**Section 2.0 - Specification for Abatement and Selective Demolition
Amendment
Submission Date: June 5, 2008**

Amendment #5 REV 02

10th Floor

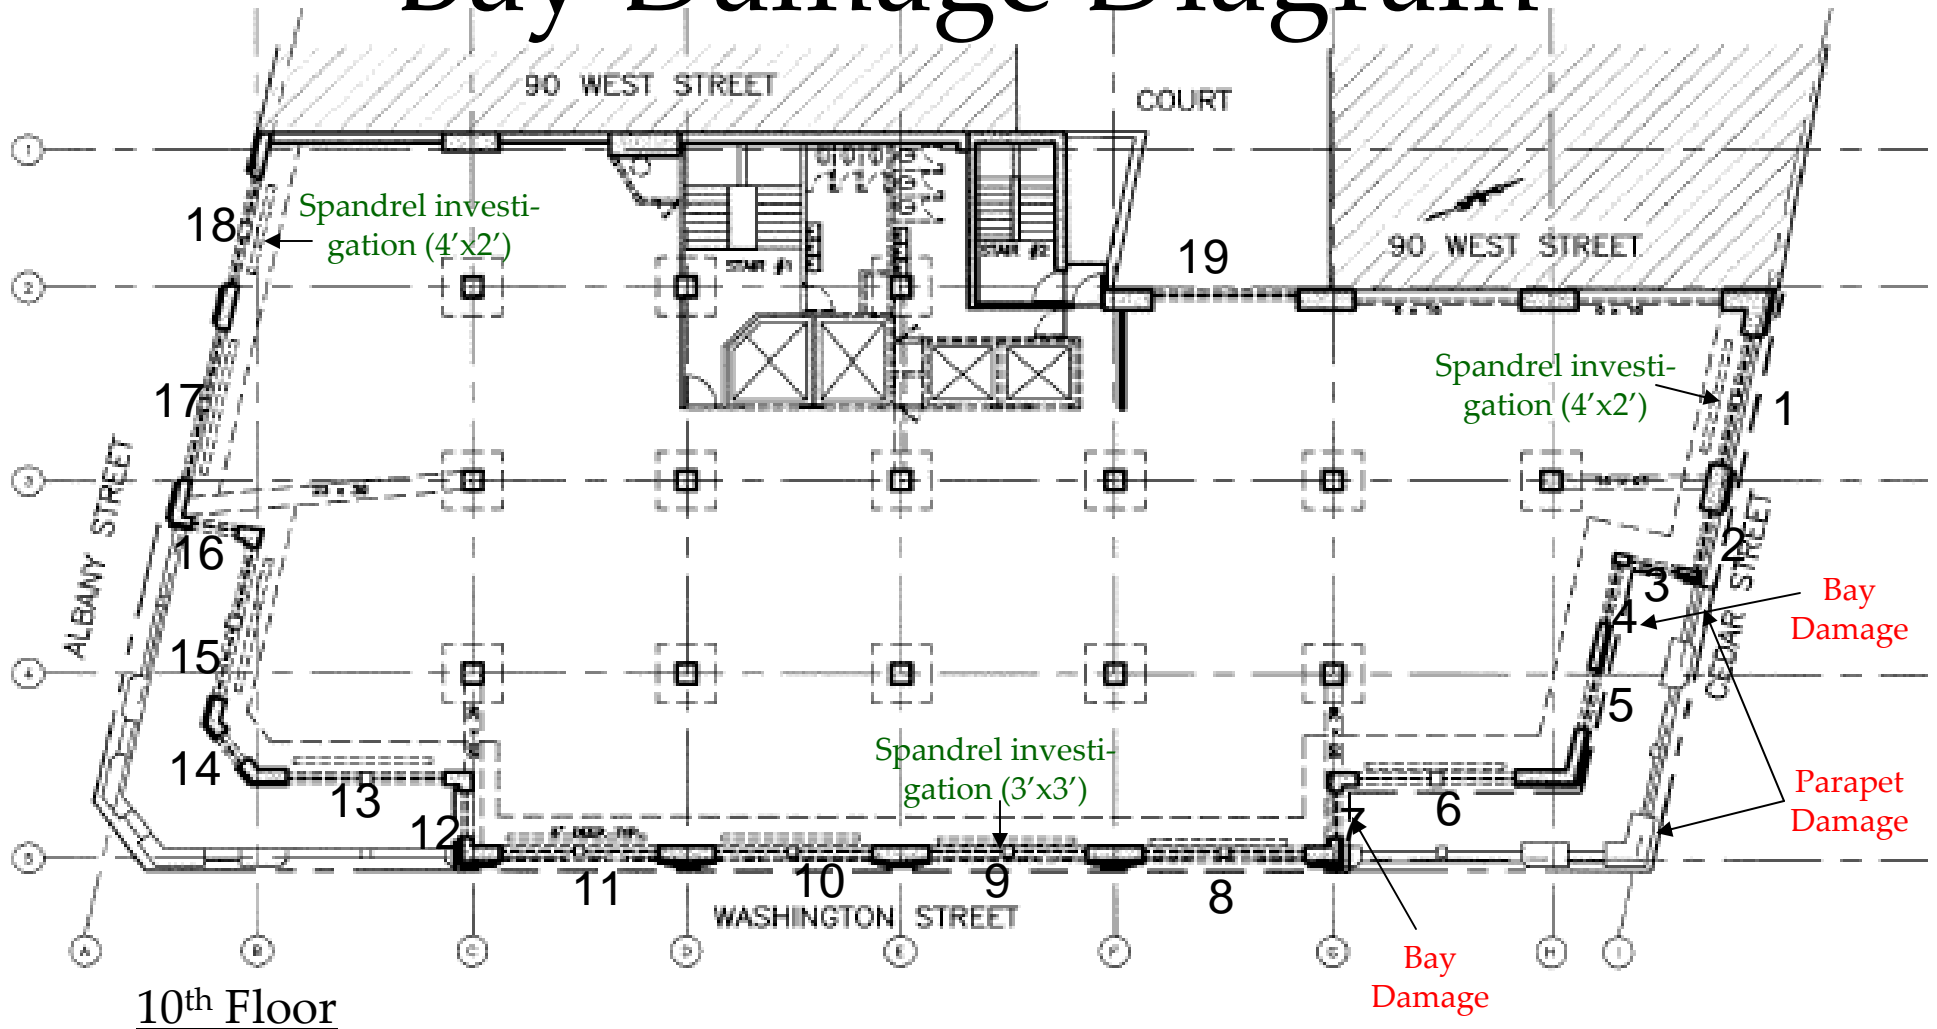
During the containment set-up on the 10th floor, RJLG was asked by Nova to verify the bay damage for bay #8 delineated on the 10th floor Bay Damage Diagram. Field inspections revealed that bay #8 was not damaged however bay #7 was. Bay #7 was not delineated on the Bay Damage Diagram as damaged. This clerical error has been corrected. Bay # 7 shows as damage on the revised bay Damage Diagram and Bay #8 does not.
